**RESOLUTION SETTING HEARING ON REQUEST FROM
QUIK TRIP CORPORATION TO REZONE PROPERTY LOCATED IN THE VICINITY OF
1930 INDIANOLA AVENUE FROM "C-1" NEIGHBORHOOD RETAIL COMMERCIAL DISTRICT
AND LIMITED "C-2" GENERAL RETAIL AND HIGHWAY-ORIENTED COMMERCIAL DISTRICT
TO "PUD" PLANNED UNIT DEVELOPMENT AND TO APPROVE PUD CONCEPTUAL PLAN**

(ZON2016-00003)

STAFF REPORT TO THE PLANNING COMMISSION

A PLANNED UNIT DEVELOPMENT (P.U.D.) IN THE CITY OF DES MOINES,
COUNTY OF POLK, STATE OF IOWA
SHEET 2 OF 3

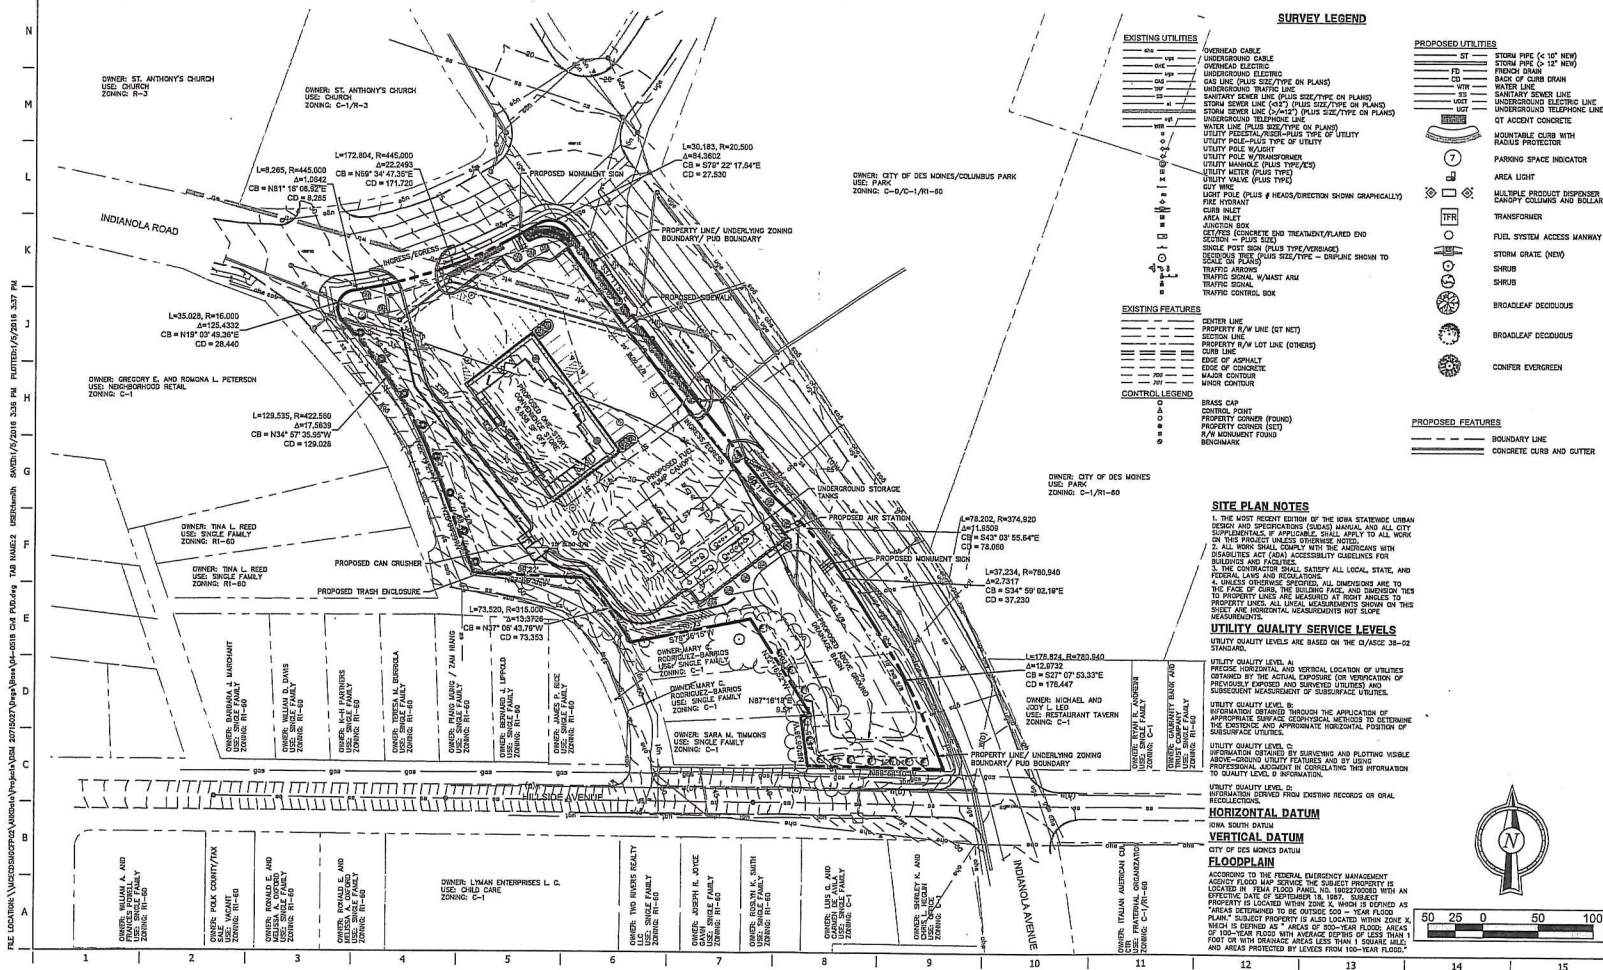
Staff believes that dedicated pedestrian routes should be provided from the Indianola Avenue and Indianola Road sidewalks to the building.

Pedestrian routes to the building are not identified on the Conceptual Plan. Staff believes dedicated pedestrian routes should be provided from the Indianola Avenue and Indianola Road sidewalks to the building.

The submitted information indicates the total canopy height would range from 18 feet, 6 inches to 23 feet due to grade. The height of the underside of the canopy would range from 15 feet to 19 feet.

The Conceptual Plan shows a mix of trees and shrubs throughout the site. Landscaping would be fully evaluated at the site plan stage. Staff believes that a note should be added that landscaping shall be provided in accordance with the City's "C-2" District Landscaping Standards or exceeded as illustrated on the Conceptual Plan. In addition, staff believes that enhanced landscaping should be provided along South Union Street to buffer the residences to the southwest.

Staff believes the proposed monument signs should comply with these standards including the provision of a solid opaque base, constructed of brick, stone, concrete block or other durable material that is no less than 2 feet in height. The base should extend from grade to the bottom of the sign face across the entire width of the sign face.

1. Any access drive from Indianola Road must consist of a right-in/right-out configuration in conjunction with the construction of a raised median in the street or other alternative approved by the City Traffic Engineer.

2. A left turn lane shall be provided on Indianola Avenue for north bound traffic turning into the site or other alternative approved by the City Traffic Engineer.

3. Provision of direct pedestrian routes from the Indianola Avenue and Indianola Road sidewalks to the building to the satisfaction of the Planning Administrator.

4. Addition of a note that states "landscaping shall be provided in accordance with the "C-2" District Standards or exceeded as illustrated on the Conceptual Plan."

5. Addition of a note that states "an enhanced level of landscaping shall be provided along South Union Street to the satisfaction of the Planning Administrator."

6. Any monument sign shall have a solid opaque base constructed of brick, stone, concrete block or other durable material that is no less than 2 feet in height as approved by the Planning Administrator and to be more compatible with the neighborhood. The base shall extend from grade to the bottom of the sign face across the entire width of the sign face.
